DATE 05/00 Amended 01/02

S303-04

New Design Dipstick – Identification – Increased Oil Fill Quantity MODEL 2000 MY-ON S-TYPE

**ILLUSTRATION 1**

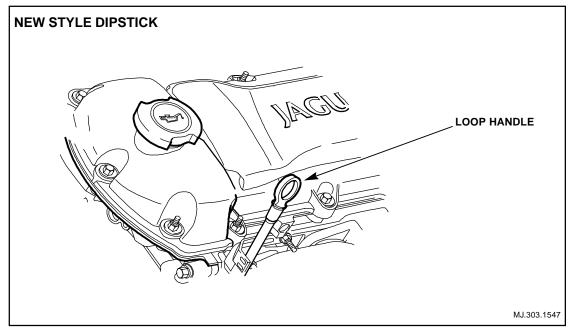
A new style oil dipstick has been introduced on all 3.0 L S-TYPE V6 vehicles from September 1999.

The new style oil level dipstick can be identified by its loop handle instead of the old T-bar design.

**Note:** Due to the service oil fill change on V6 engines from 5.7 liters (6.02 qts.) to **6.5** liters (**6.87** qts.), the oil fill mark on the dipstick has been altered by **14** mm (.55 in.).

The new style dipstick is shown in Illustration 1.
